Subject: CERTIFICATE OF COMPLIANCE NO. 9297 FOR THE MODEL NO.
TRAVELLER PACKAGE, RESPONSE TO NRC REQUEST FOR
ADDITIONAL INFORMATION (RAI)

Request for Additional Information
Model No. Traveller
Docket No. 71-9297

Chapter 2 Structural Evaluation

Figure 2-1A Sample of Clamshell Accelerations Measured During Road Test (May 11, 2004)

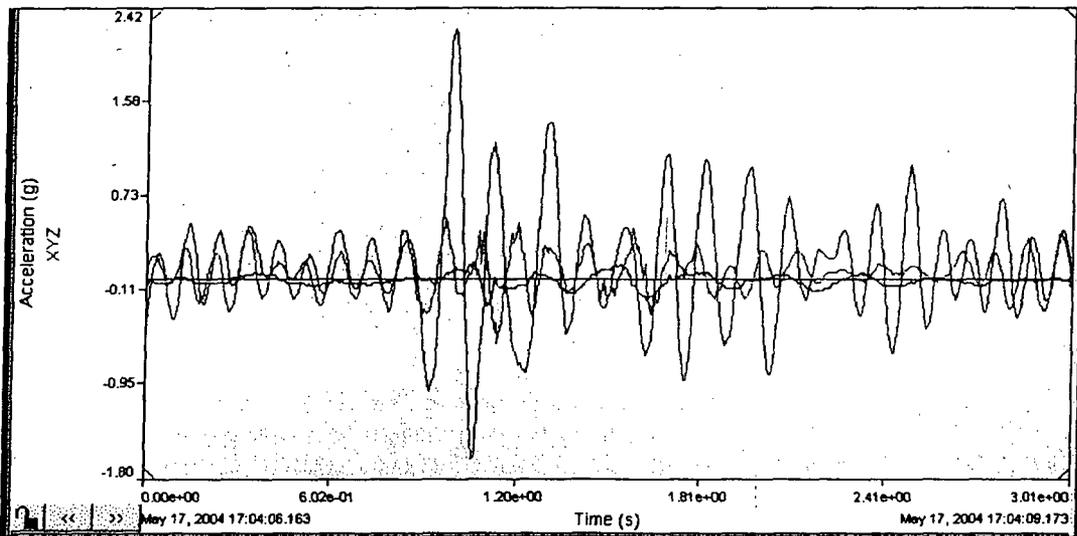
- 2-3 Revise Section 2.6.5 to include an evaluation of vibration frequencies of the Clamshell-shock mount system to ensure that no resonant vibration conditions could occur yet result in damage to the Clamshell and its contents during normal conditions of transport.

The following text and figure have been added to Section 2.6.5:

There are several natural frequencies of the shock mount system depending on direction of movement. The dominant frequency is for vertical movement. This frequency is between 5.9 and 6.7 Hz (for Traveller XL) depending on the weight of the fuel assembly being transported. The fore and aft pitch frequency is slightly higher (6.9-7.9 Hz) but has a lower amplitude. Road tests have been performed with the suspension system to measure amplitudes during shipping. Figure 2-1A is characteristic of the results seen. When the truck travels over a bump, the clamshell initially sees relatively large accelerations (2-3 g's) but this oscillation quickly damps out to accelerations less than 1 g. This 300 mi trip involved approximately five and a half hours on the road with 1.4×10^5 total cycles.

Figure 2-1B Impact Limiter "Pillow" Assembly

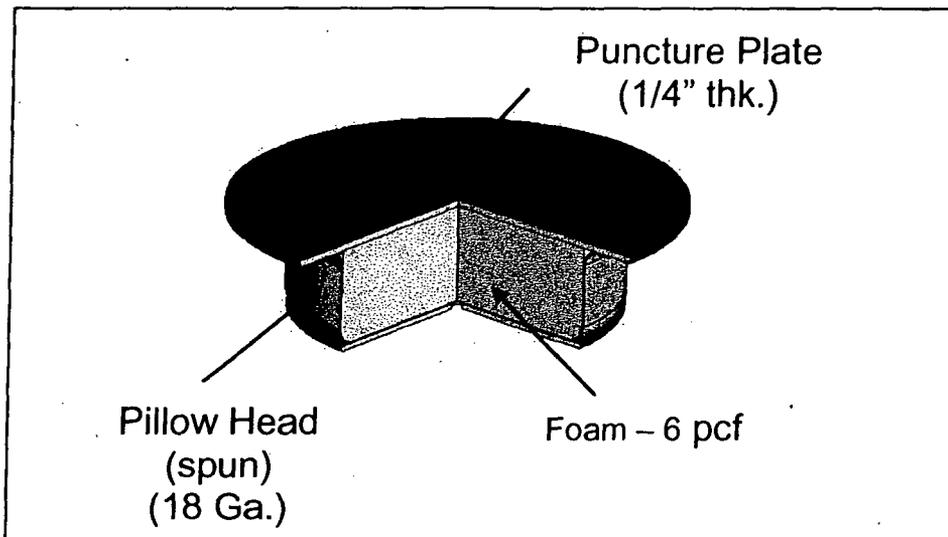
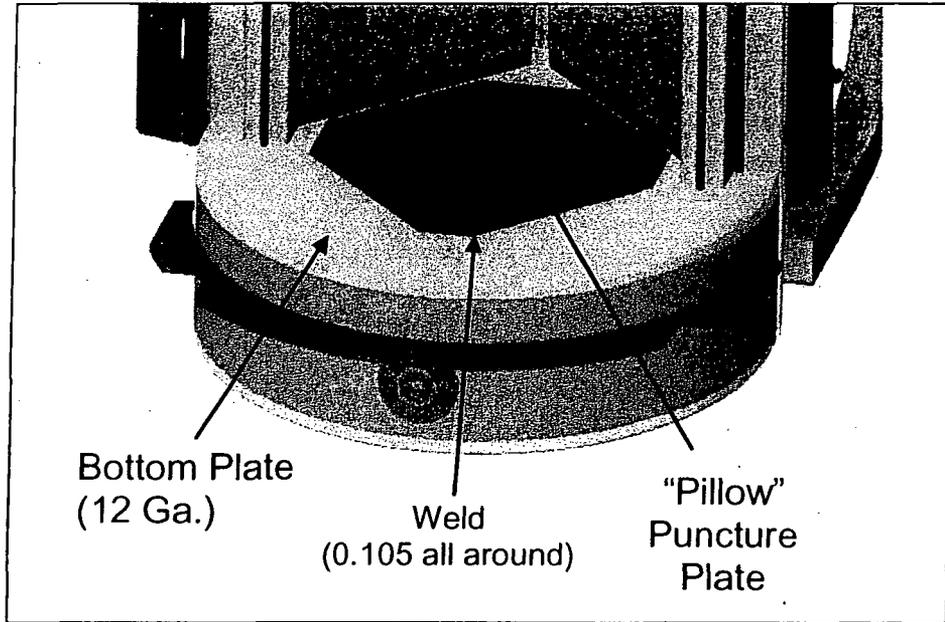
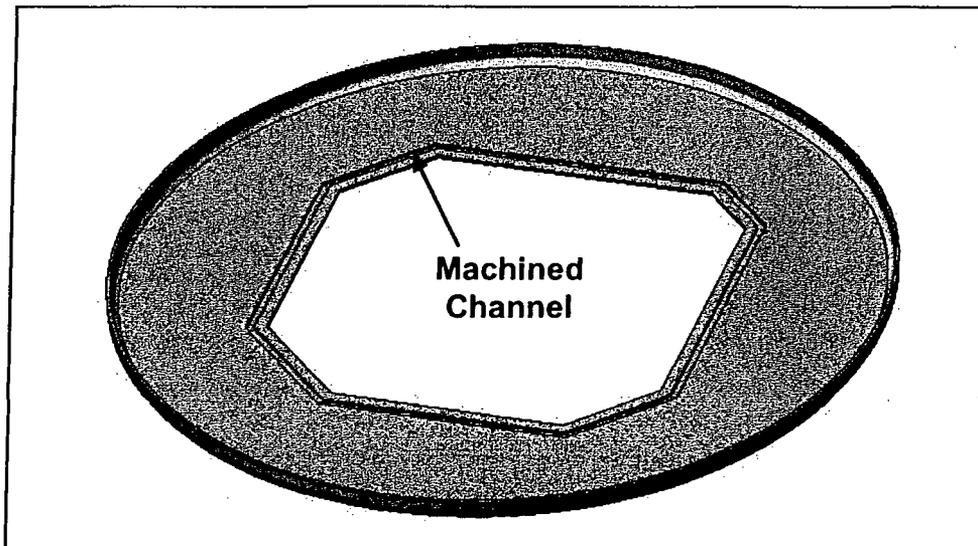
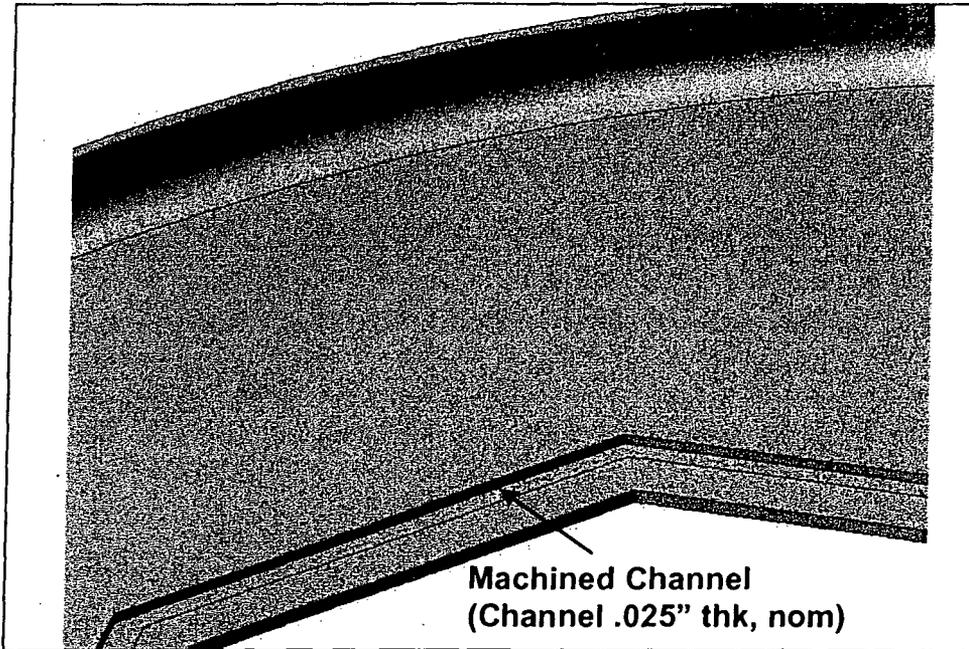
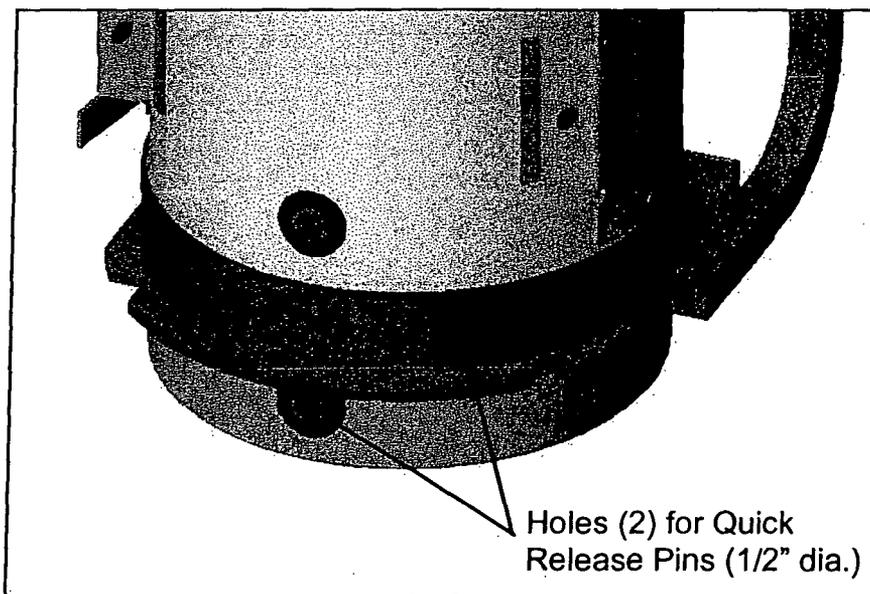
2-5 Provide drawing details for the design changes introduced to the Certification Test Unit drop tests to improve performance of the package, including welding of the impact limiter pillow to the Outerpack liner plate and modification of the quick release pin. Changes to the packaging features that are important to safety should properly be presented in design drawings (Table 2-5, Page 2-22).

The following text and figures have been added to Table 2-5:

The figure below (Figure 2-1B) shows the impact limiter, or Pillow, assembly (shown without insulation). This assembly is shown installed in the Traveller package bottom (the configurations are the same for STD and XL packages) in Figure 2-1C. The weld between the bottom plate (yellow) and the puncture plate (red) is also shown. During testing this weld failed as expected, however, it did not completely allow the components to separate. This design change weakens the bottom plate by reducing its thickness to a nominal 0.025" thickness, as shown in Figures 2-1D and 2-1E. A .25 inch wide channel was added to weaken the part.

The CTU design included a pinned connection (2 quick release pins – 0.5" diameter) between Outerpack halves at the bottom end of the package. Quick release pins were designed to help prevent the halves from warping and opening a gap locally during fire testing. Figure 2-1F shows the location of the quick release pins. During drop testing, the pins failed, therefore, they could not be used in the fire testing.

Figure 2-117A Accelerometer Locations on Prototype Drop Test

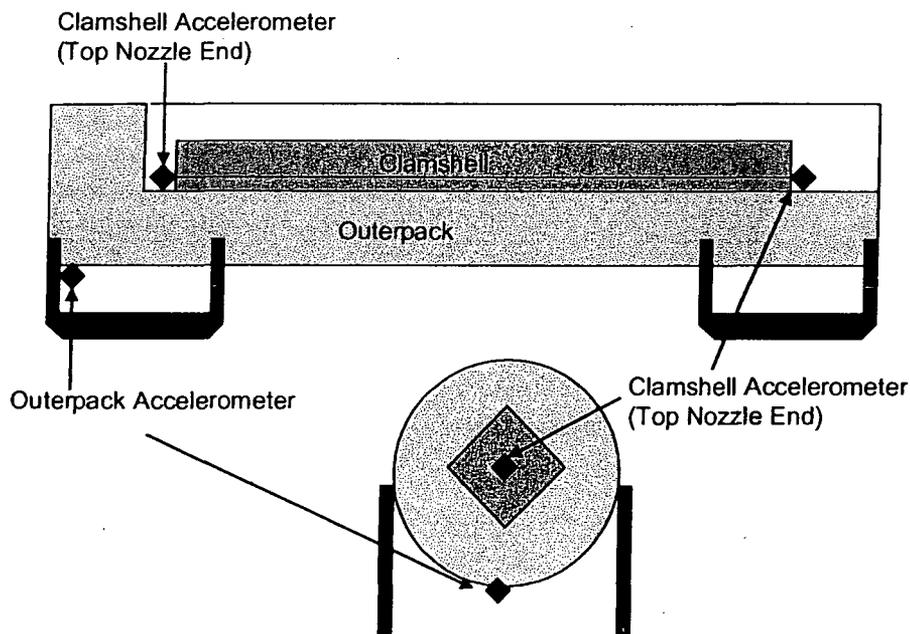
- 2-18 Provide sketches depicting the accelerometer installation plan for the drop tests. The application should include accelerometer locations on the test articles to evaluate correlation between the measured and predicted results.

The following text and Figure 2-117A have been added to Section 2.12.4:

The locations of these accelerometers are shown in Figure 2-117A.

Figure 2-108 Stress-Strain Characteristics of Aluminum in Clamshell

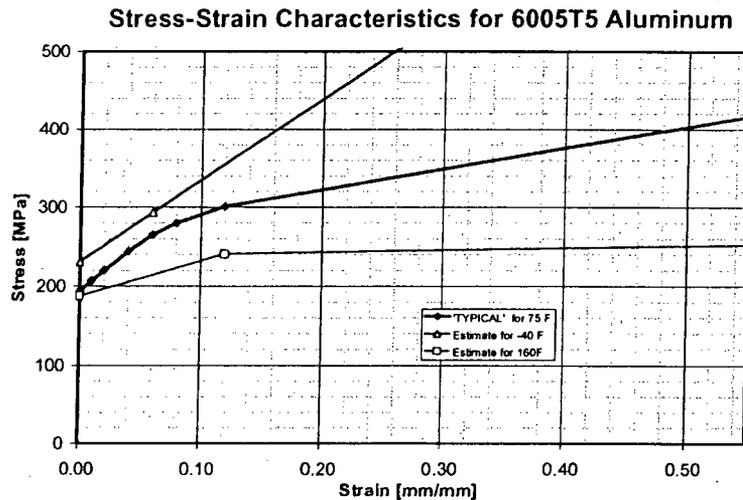
- 2-21 Verify the temperature-dependence stress-strain curve plots, Figure 2-108, for the Clamshell aluminum at 160° F and -40° F. The stress-strain curves at the two temperatures appear to have been mislabeled.

The following figure, Figure 2-108 has been replaced:

Figure 2-95 Impact Limiter in Prototype Unit Model

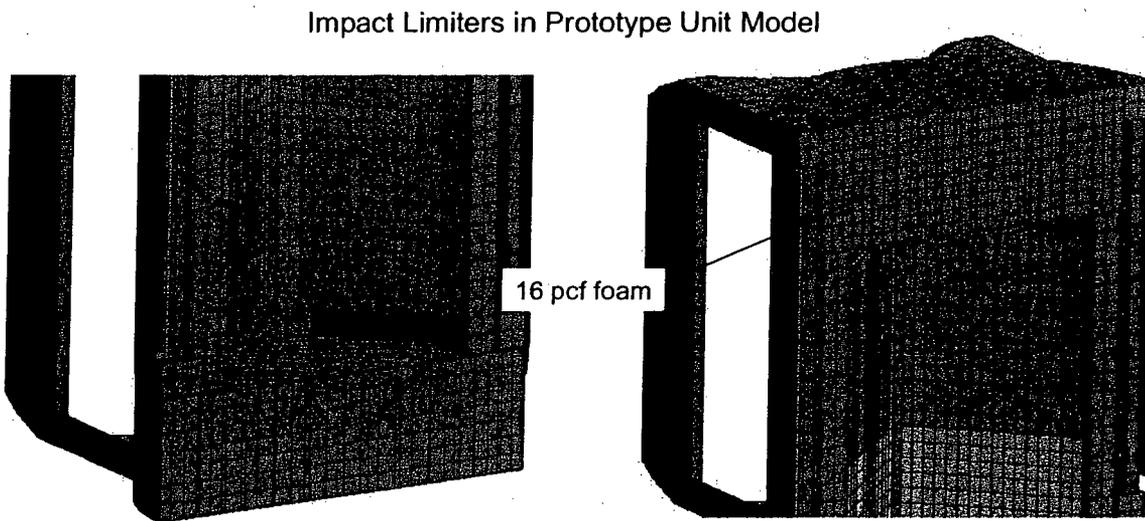
- 2-25 Provide a discussion clarifying the apparent discrepancy between the statement provided on page 2-148, "[t]he prototype packages employed 11 pcf foam along the axial section of the package and 16 pcf foam in the endcaps," and the information provided in Figures 2-95 and 2-112 which indicate that the end cap for the Prototype Test Unit was filled with the 11 pcf, rather than the 16 pcf, foam.

The following figure, Figure 2-95, has been replaced:

Figure 2-91 Predicted and Measured Y Accelerations

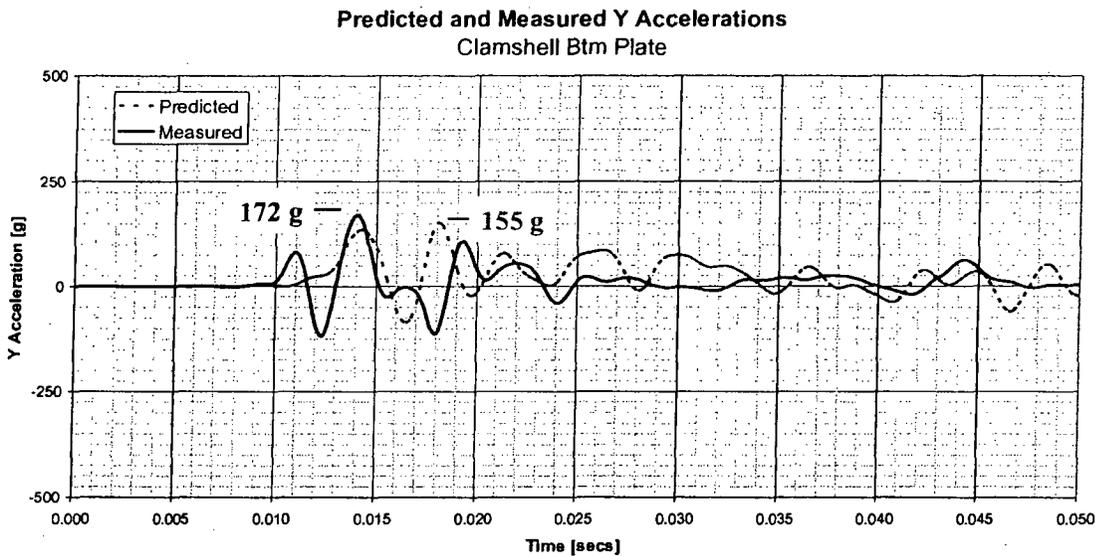
- 2-27 Provide a discussion explaining the apparent discrepancy between the measured vertical decelerations of 191 g in Table 2-30 and 205 g in Figure 2-91.

The following figure, Figure 2-91, has been replaced:

Figure 2-129 Drop Orientation for QTU Test Series 1

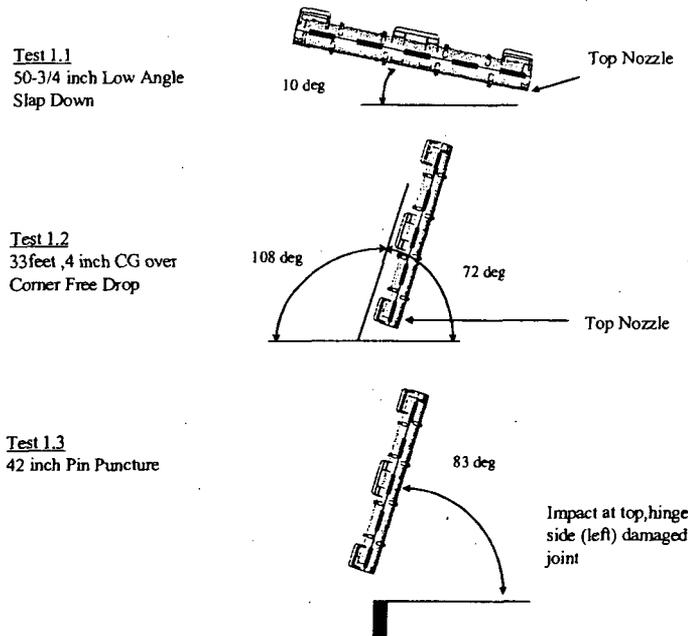
- 2-28 Provide a discussion clarifying the drop angle/orientation depictions of Test 1.2 and Test 1.3 in Figure 2-129 for the respective CG-Over-Corner and pin puncture tests. It is not clear how the drop angle of 108° was defined for Test 1.2. The puncture drop of Test 1.3 does not appear to have the package hinge side of the Outerpack land on the puncture pin as described in the text.

The following text has been added to Section 2.12.4.2.1 and Figure 2-129 has been replaced:

A pitch angle of 72 degrees was measured along the outerpack surface for Test 1.2. The angle of 108 degrees should be located as shown in Figure 2-129. The reference to "hinge side" in Test 1.3 indicates the package side that pivots, rather than the actual hinge. The impact point of Test 1.3 (Figure 2-132) was on the top nozzle end and on the pivot (left) side of the package.

Figure 3-27A Orientation of CTU for Thermal Test

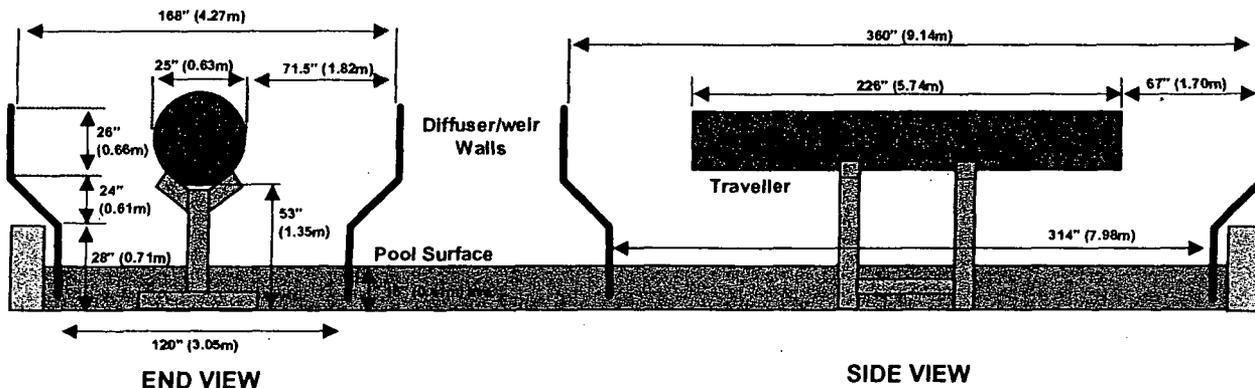
- 3-1 Revise the SAR to specify the orientation of the certified test unit (CTU) with regard to the fire test pool. Specifically, state the distance the bottom of the package was positioned above the fire pool surface and the distance the pool extended beyond the ends of the package.

The following text and figure have been added to Section 3.6.4:

Figure 3-27A shows the orientation of the Certification Test Unit (CTU) for the thermal test. The bottom of the package was positioned approximately 1 meter from the top of the fire pool surface. The distance of the outer facility walls beyond the edge of the package were 67" at the ends and 71.5" at the sides.

Figure 3-27B Fire Fighters Standing by Fire Suppression System

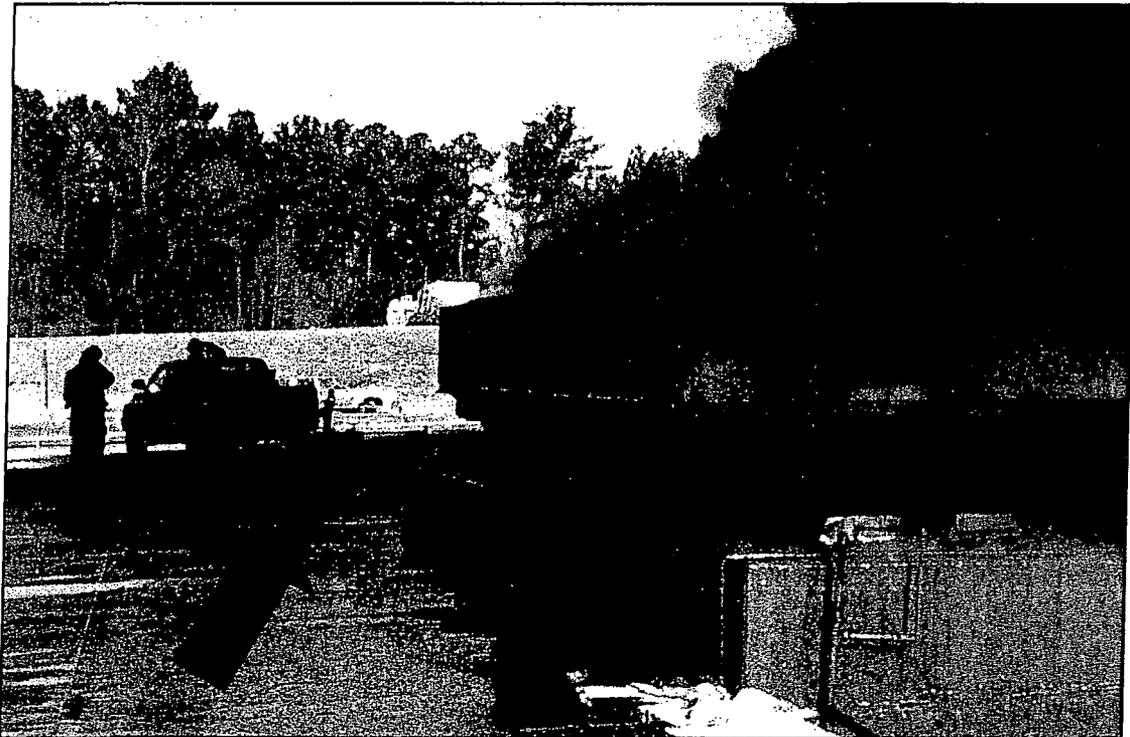
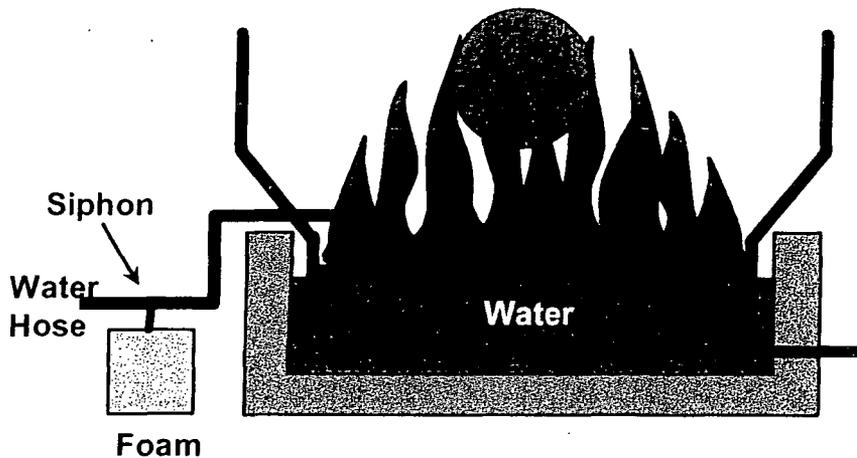
- 3-10 Revise the SAR to clearly state that the package after the fire test was allowed to burn until it naturally extinguished. Also, include a discussion why none of the means used to extinguish the pool fire had any adverse impact on allowing the package to burn as long as it naturally could.

The following text and Figures 3-27B and 3-27C have been added to Section 3.6.4:

The fire test facility was originally designed to terminate the fire test by shutting off fuel flow and allowing the fuel at the surface of the pool to burn off. Testing revealed that, in some circumstances, excess fuel could buildup on the pool surface causing the fire to continue burning for five minutes or longer. As a result, a simple fire suppression system was added to the facility. A water hose was connected to a nearby fire hydrant, Figure 3-27B. This hose utilized a suction line to siphon standard fire suppressant foam into the line, Figure 3-27C. The hose discharged into a single pipe that fed into the pool a few inches above the water level. When activated, the system would inject foam horizontally onto the surface of the pool, well below the test article. When used in combination with the fuel shutoff valves, the pool fire was extinguished within 60 seconds. This system did not cool the test article when in use and the package was allowed to naturally extinguish itself after the test. This was demonstrated by the CTU burn test, where the polyurethane at the Outerpack vent ports continued to burn many minutes after the fire suppressant was used on the pool surface.
